**NOTICE IS HEREBY GIVEN** that a special meeting of the Village Board of the Village of Neosho shall be held on **Thursday, November 16, 2023**, 6:30 p.m., at the Neosho Village Hall, 210 S. Schuyler Street, Neosho WI.

Re: Assessment of Recommended or Required Actions  
Neosho Dam, Rubicon River

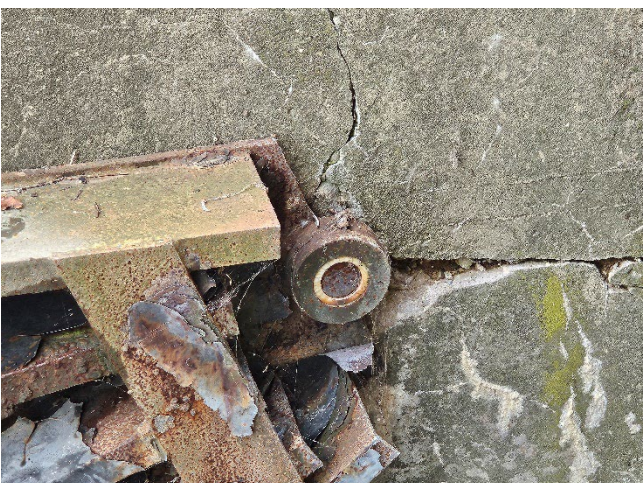
**Critical Item: Vibration.** We witnessed continuous vibration emanating from the radial gate and extending around the gate into the supporting concrete constraints. This vibration is believed to be, in our opinion, created from the weir flow hydraulics of the radial gate. That is, the water being allowed to overflow the radial gate is weir flow that drops 6-7' to the concrete flume, but in the majority of flow conditions, it is cascading along the back girders of the gate, creating a water force upon the center of the girders. This force is believed to be creating a vibration on the radial pinned structure in suspension. The vibration is a major problem for older concrete, as evidenced from the excessive surficial spalling around the entire gate structure. This condition can be immediately remediated by raising the gate to cut-off the upper weir flow. High flows will require extensive monitoring to try to manage a potentially catastrophic situation upon the

gate, although it is likely that higher flows will not cascade downward as much as low flows. Alternate solutions include installing an upper metal plate attachment on the gate to disallow high flows over the gate, or installing a weir flow attachment to extend over the gate to preclude the possibility of water cascading downward onto the girders. All temporary options mentioned herein will alter the hydraulics that were likely included in the design and could potentially alter downstream expectations for the operation of the dam.
